DIXIE-NARCO, INC.
SERVICE BULLETIN #138

MODELS: All Serpentine Can Venders With The Open Type Relay
(Guardian - Blue Coil)

SUBJECT: Installation of RBM Open Type Relay

Figure 1. RBM Relay

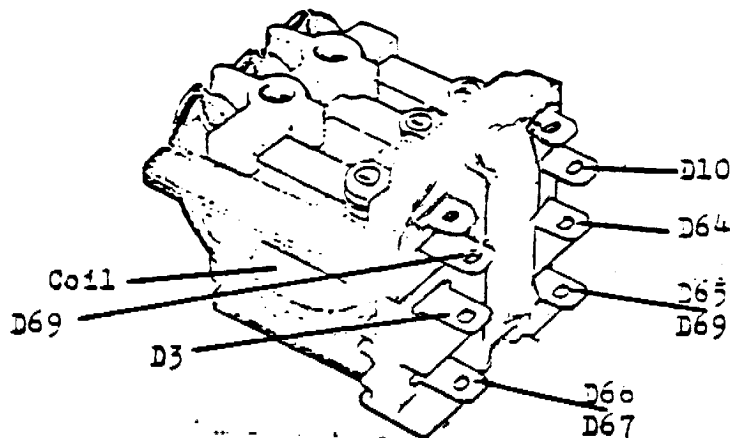
REASON: The Guardian Relay has been phased out and is being replaced
with the smaller RBM Relay for purpose of standardization.

1. Refer to Figure 1, RBM Relay.
2. Remove the Guardian Relay.
3. Hold the RBM Relay in the position shown in
Figure 1. (Coil down).
4. Attach the appropriate "wire lead" to the terminals
on the relay as shown.
5. Install New Wiring Diagram - A903, 804,710.11
and secure relay in position with screw.
